ABP-318540-23

**Proposed Open Cycle Gas Turbine (OCGT) at Tarbert Power Station,
Tarbert.**

**Submission to An Bord Pleanála by the Development Management Section
of Kerry County Council.**

Figure 9: Location of Flooding areas on the site as indicated by Floodinginfo.ie

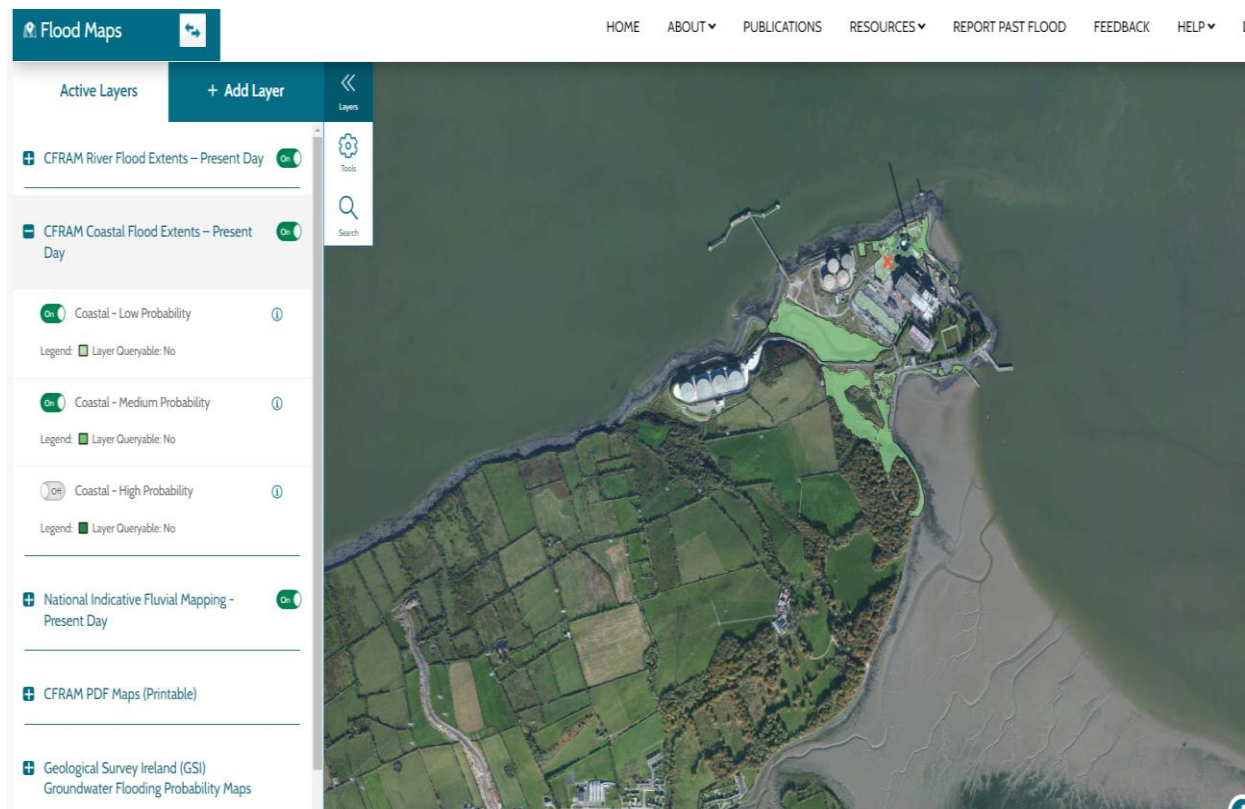
The Coastal and Flooding Unit have provided a report. The report indicates that the proposed development is classified as a *Highly Vulnerable Development* and within Flood Zone A, and that a *Justification Test* is required, which must quantify the flood risk at the proposed development and where necessary mitigate this flood risk.

The Unit recommends that given the Highly Vulnerable classification of the development, it would be more prudent to design for the more conservative Option 3 (See Section 5; Conclusion, Stage 2 Flood Risk Assessment (appendix 12 A)) with finished Flood Wall/Gate levels of +5.2m OD Malin (+7.9m OD Poolbeg) as against the +7.54m OD Poolbeg indicated in the drawings.
